## CMB Meeting Minutes #167

SUBJECT: Configuration Management Board Meeting # 167 – Rev. No. 0

Impacts of Change UMS Shoring Impacts 48" AT&T Pipe

Change Order Request (COR 69) Amount Not To Exceed  
~~\$35,714~~ \$ 30,000

**THIRD STREET LIGHT RAIL  
CENTRAL SUBWAY  
WALL DEMOLITION  
SAN FRANCISCO, CA.  
EXCAVATION SHORING PLAN**

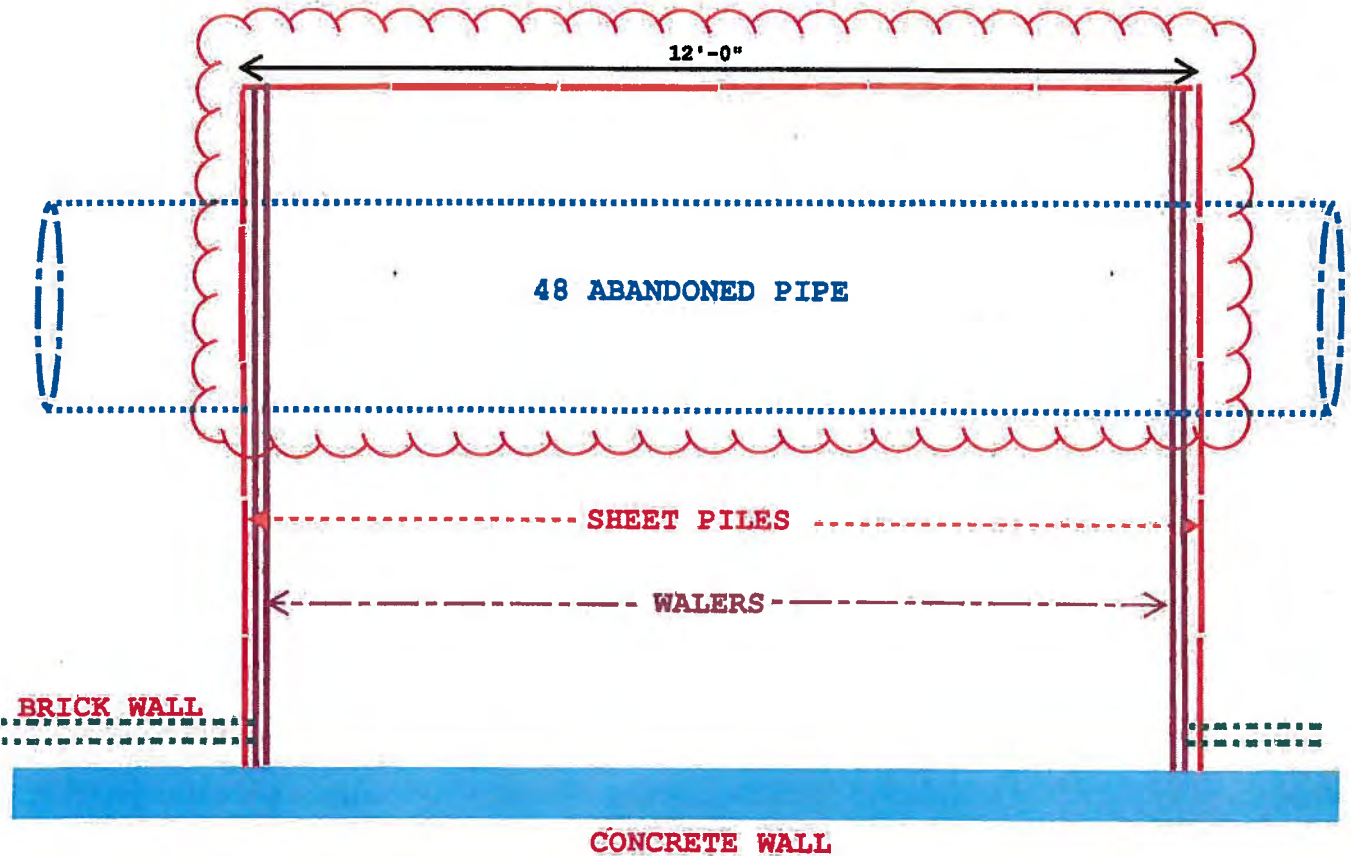
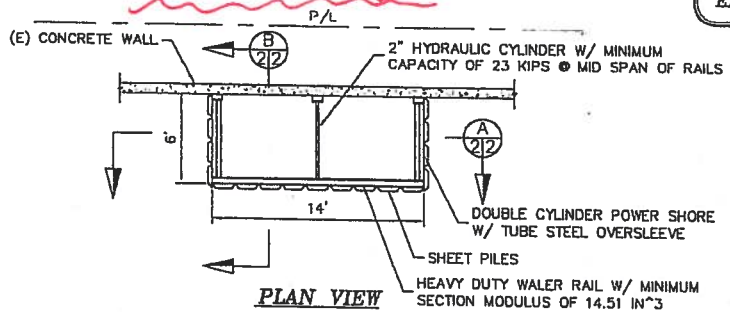
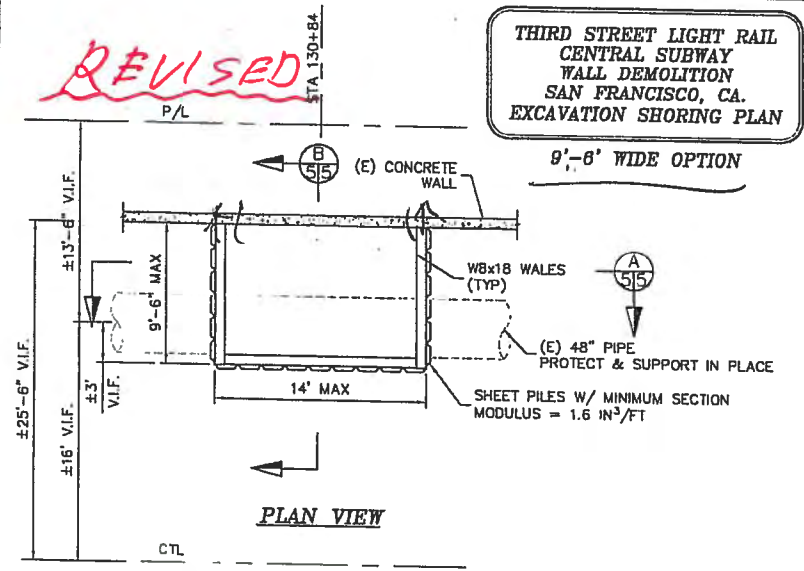
Additional work at SW corner of O'Farrell & Stockton St. to enlarge the excavation and modify the shoring at the UMS SW head wall due to presence of 48" AT&T pipe. Due to conflict with an existing 48" pipe a larger excavation pit (9.5'W x 14'L x 20'Deep) was constructed instead of the original (6'W x 14'L x 20' Deep) pit. The estimate includes quantities based on the difference between the original and revised size of the excavation pit. The estimate also includes the F&I cost of revised internal bracing from hydraulic power shores to welded W8 x 18 wales. The work was broken into meaningful activities shown below:

PIPE PREVENTED SHEETS FROM BEING INSTALLED EITHER LOCATION AND THEREFORE SYNERGY'S ORIGINAL SHORING DESIGN COULD NOT BE USED

PIPE RESULTED IN A CHANGE OF SHORING AND 40% LARGER EXCAVATION

**THIRD STREET LIGHT RAIL  
CENTRAL SUBWAY  
WALL DEMOLITION  
SAN FRANCISCO, CA.  
EXCAVATION SHORING PLAN**

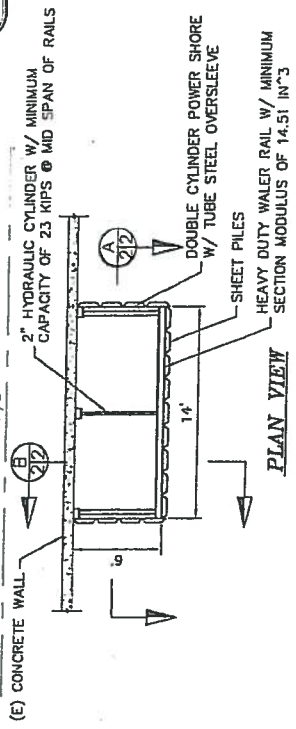
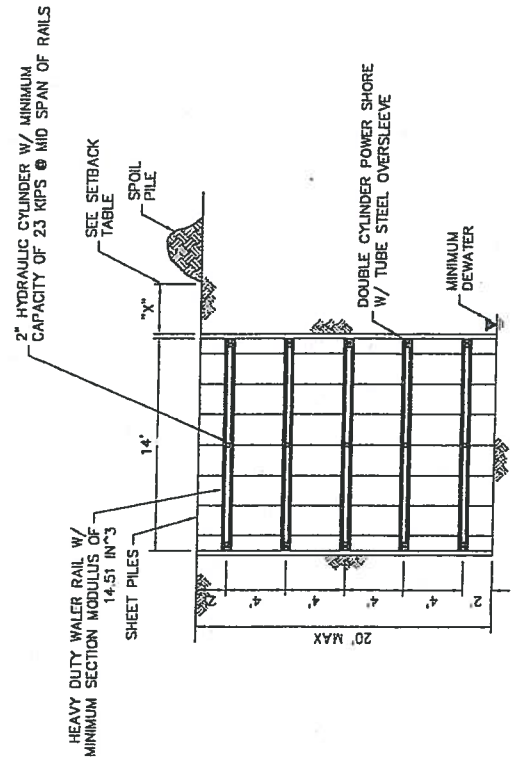
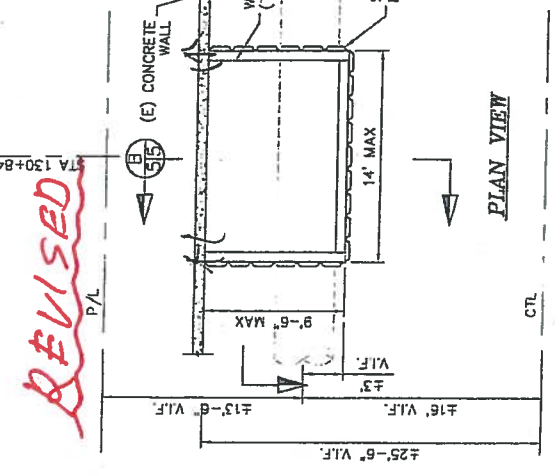
## SHORING IMPACTS DUE TO ENLARGED PIT:
